STATE OF MAINE  
DEPARTMENT OF TRANSPORTATION  
16 STATE HOUSE STATION  
AUGUSTA, MAINE 04333-0016

October 17, 2025  
Subject: Dover Bridge  
Bridge Replacement State  
WIN 023120.00  
Location: Dover-Foxcroft  
Amendment No. 2

Please make the following changes to the Bid Documents:

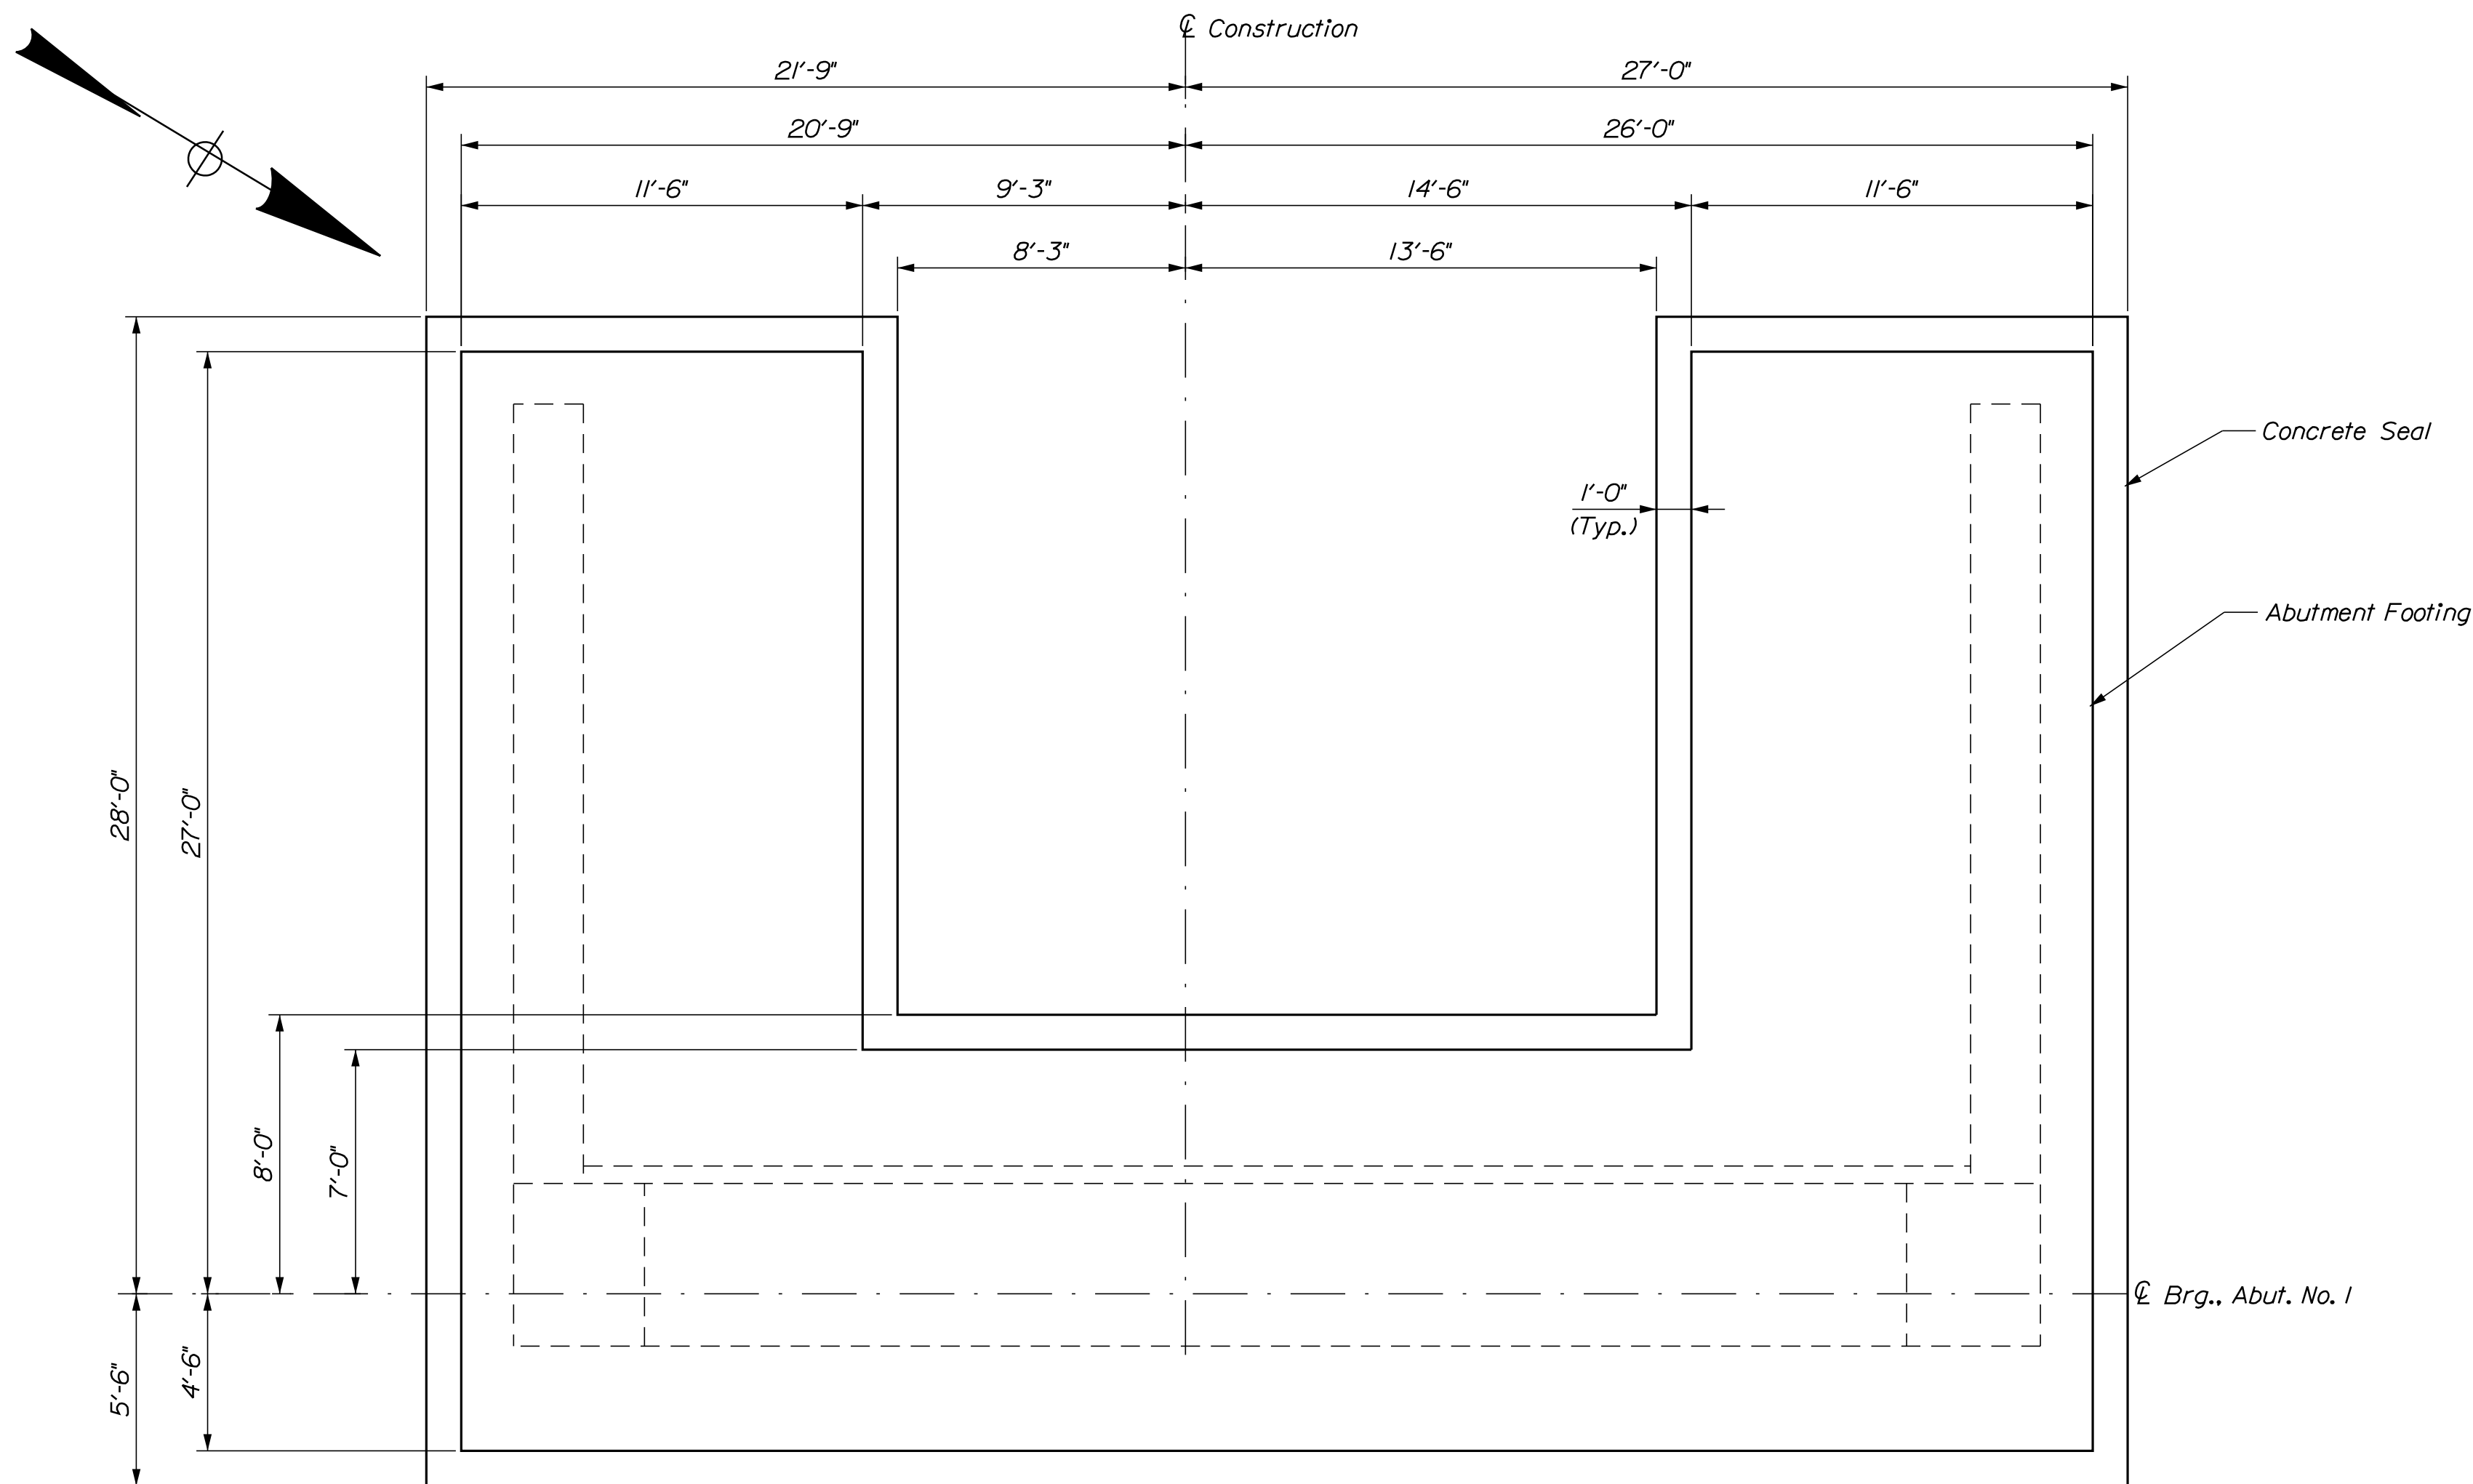
**REMOVE SHEET NUMBER 30 OF 64, ABUTMENT NO. 1 FOOTING AND SEAL PLAN**, dated 8/27/2025, and **REPLACE** with the attached, revised **SHEET NUMBER 30 OF 64, ABUTMENT NO. 1 FOOTING AND SEAL PLAN**, dated 9/18/2025.

SHEET NUMBER	34
OF 64

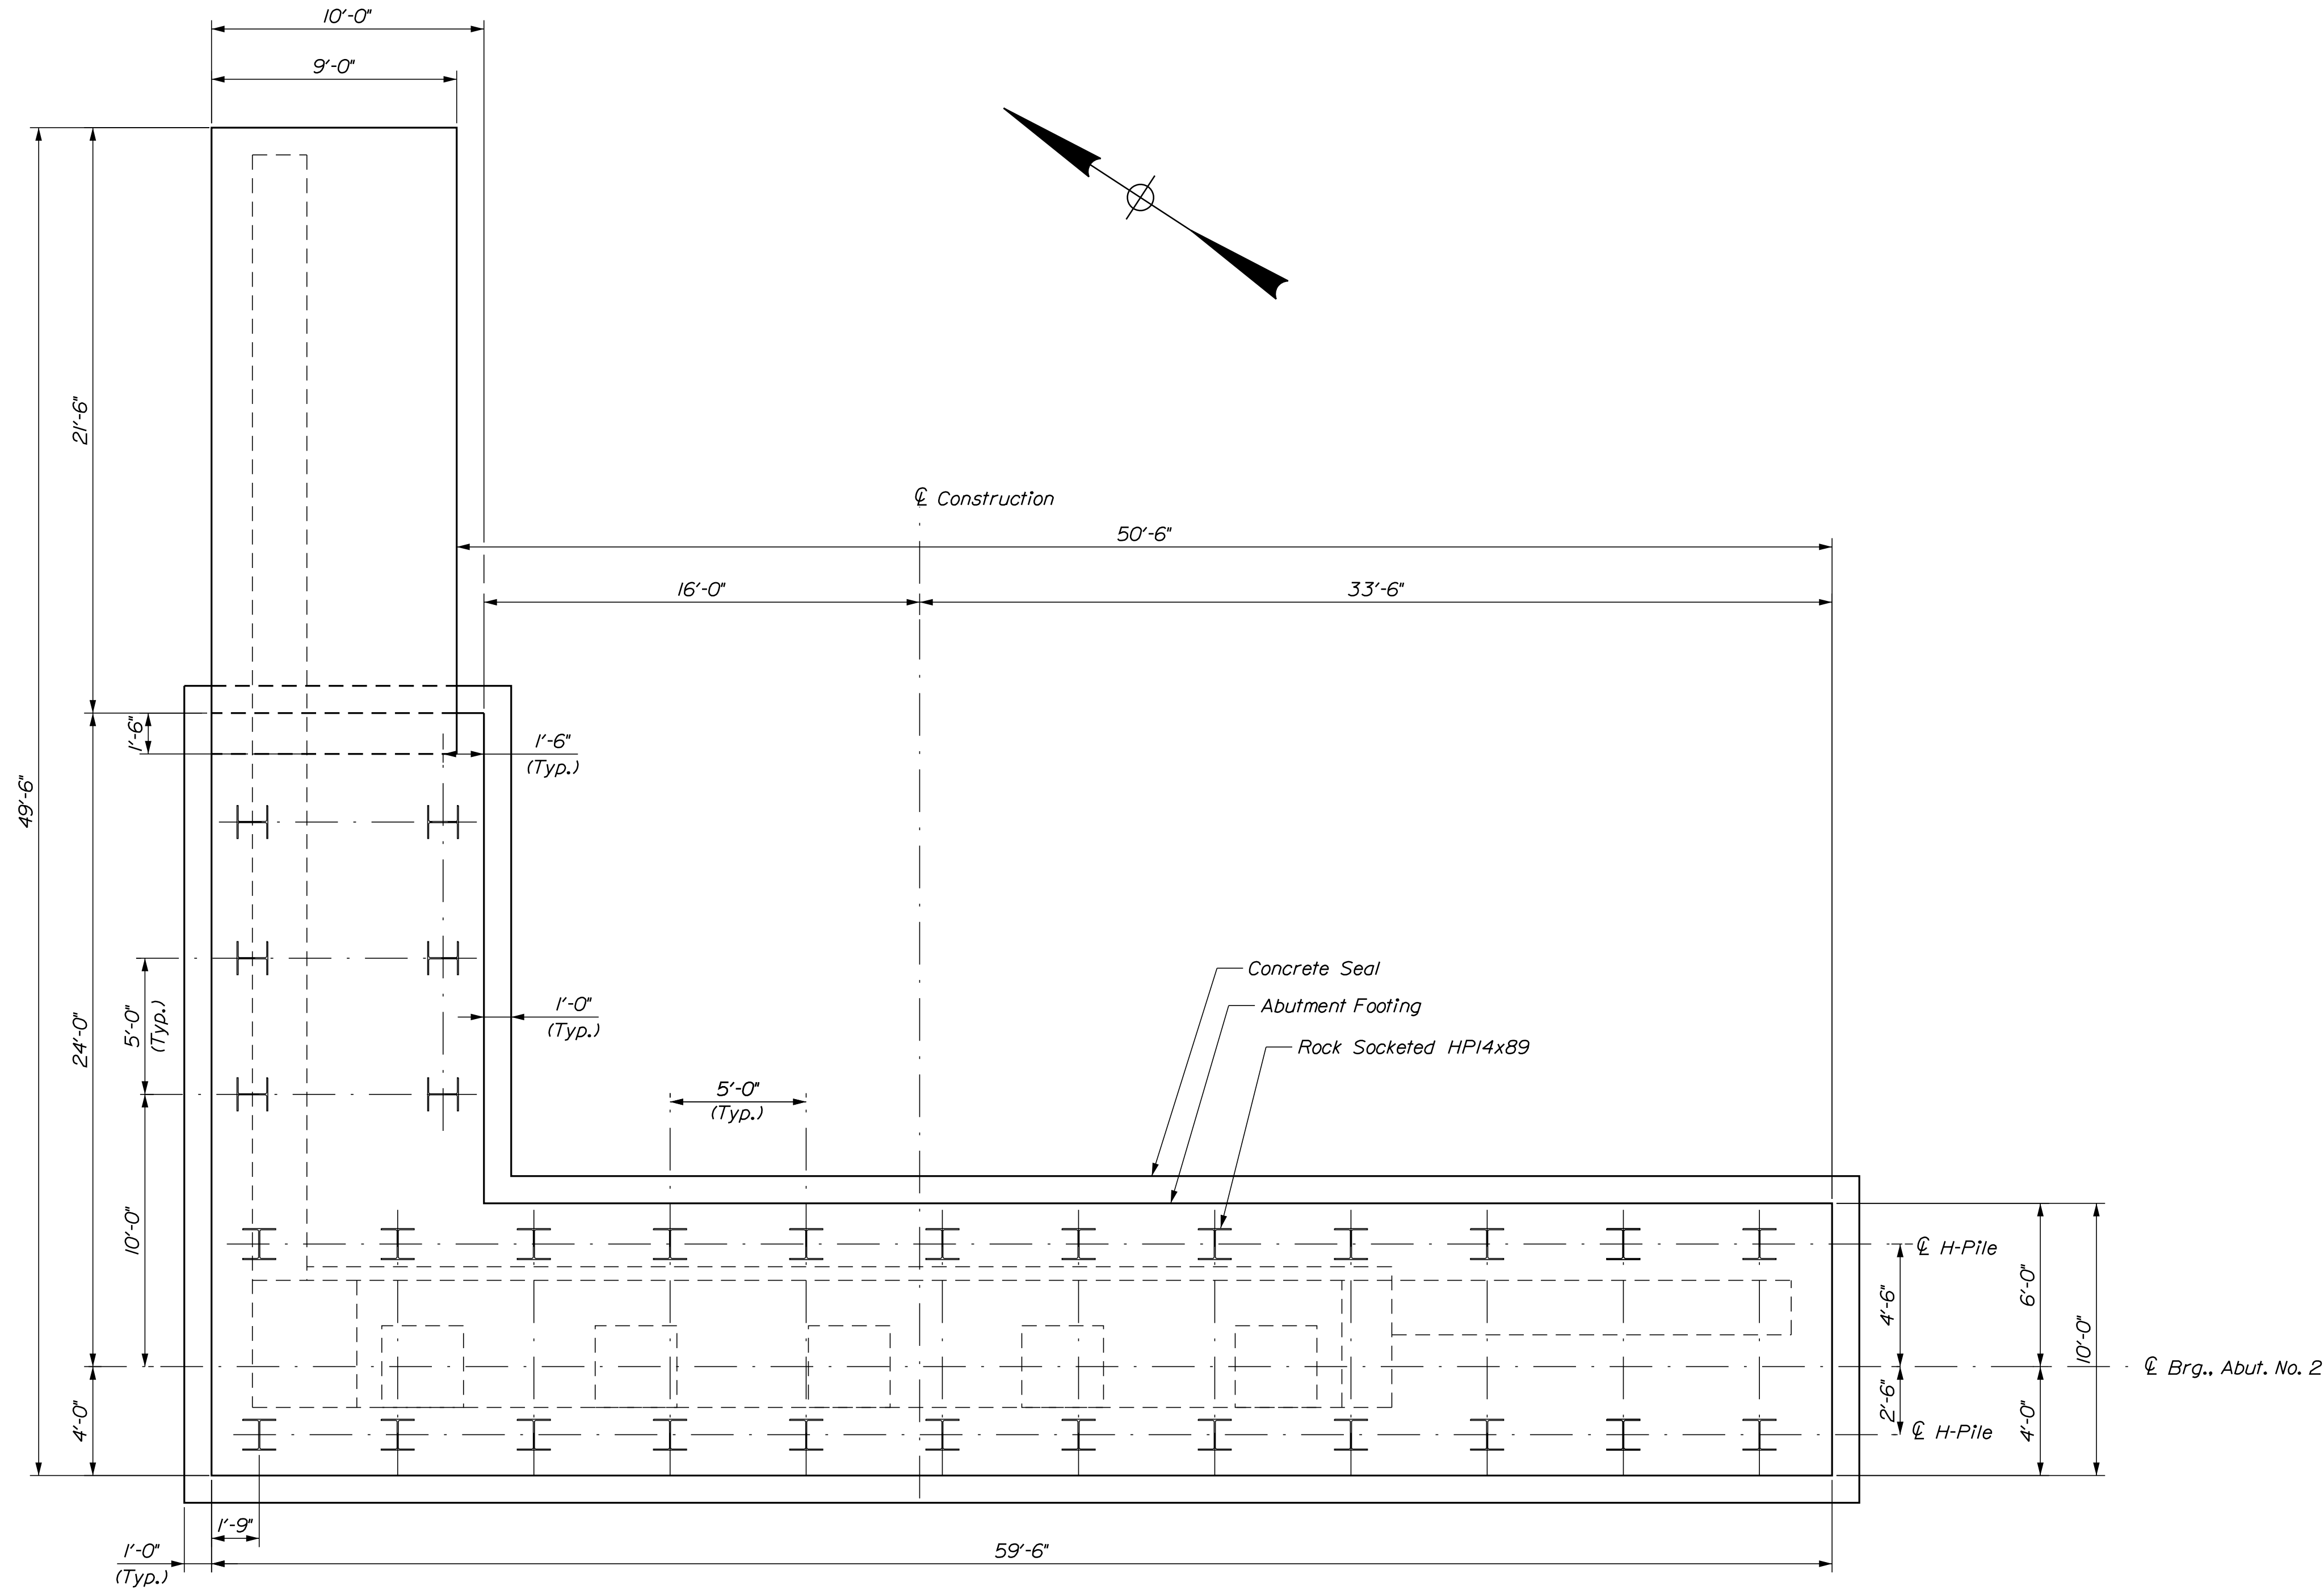
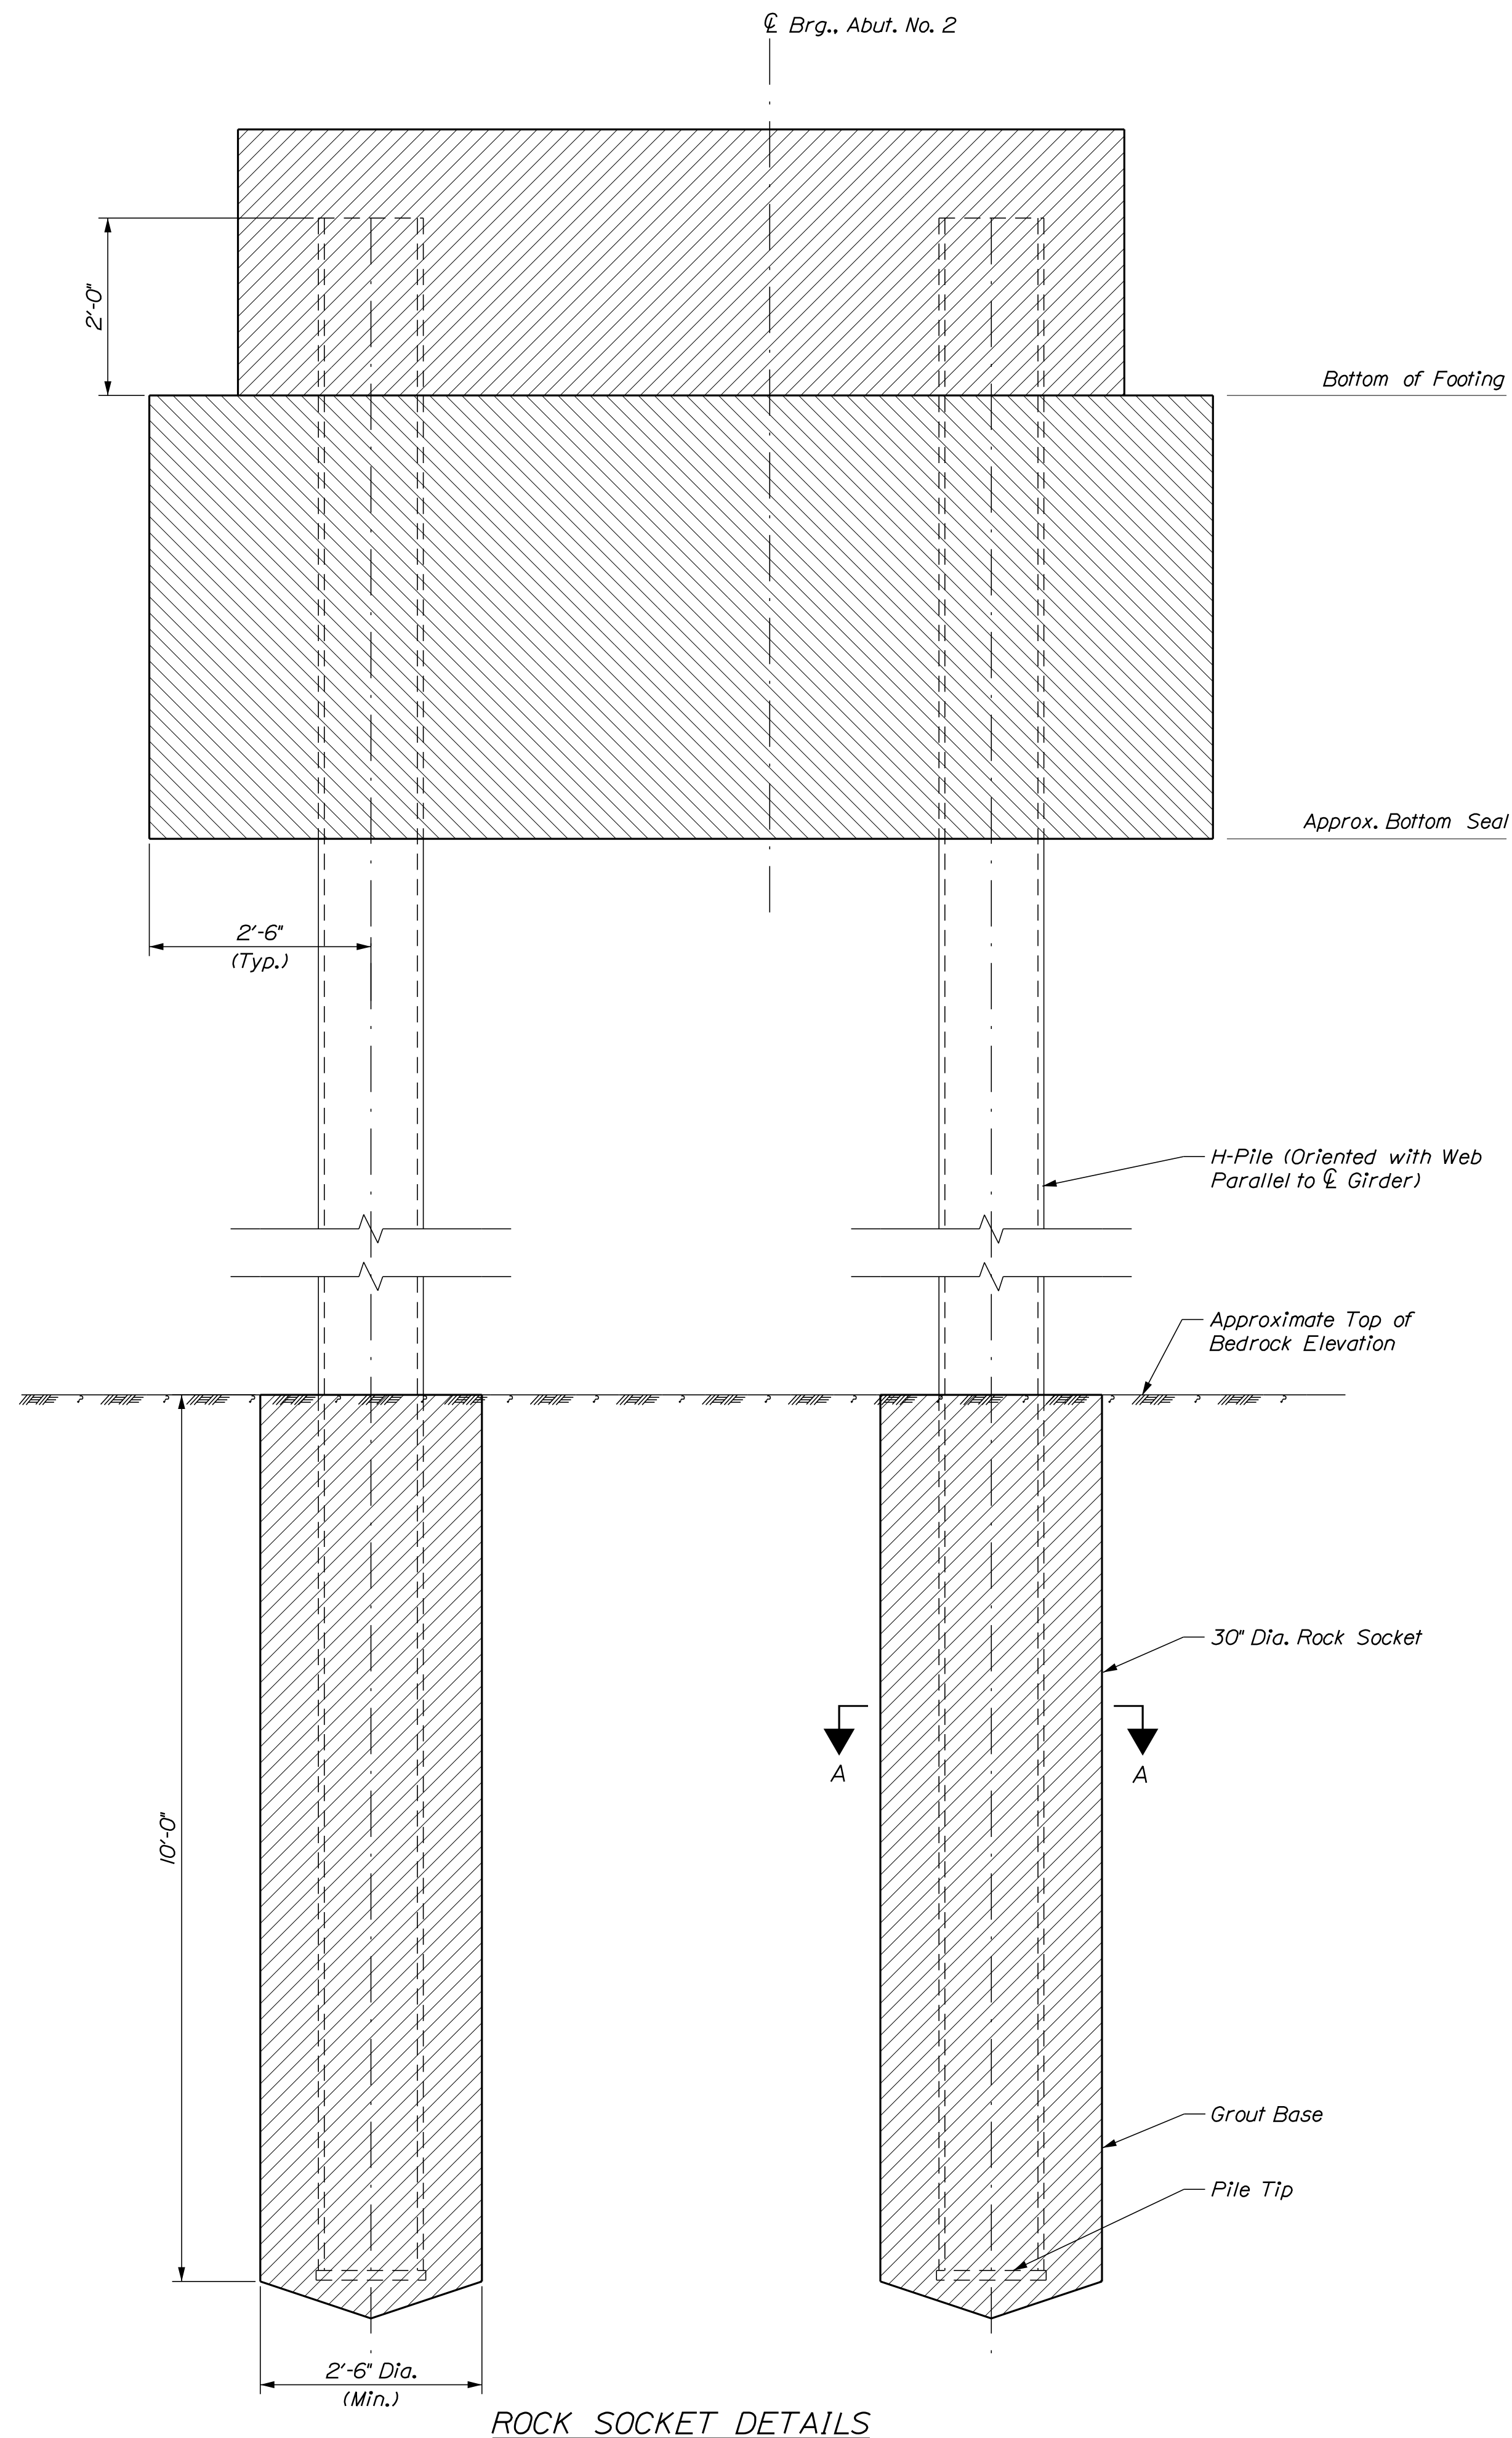
**REMOVE SHEET NUMBER 34 OF 64, ABUTMENT NO. 2 FOOTING PLAN AND PILE LAYOUT**, dated 8/27/2025, and **REPLACE** with the attached, revised **SHEET NUMBER 34 OF 64, ABUTMENT NO. 2 FOOTING PLAN AND PILE LAYOUT**, dated 9/24/2025.
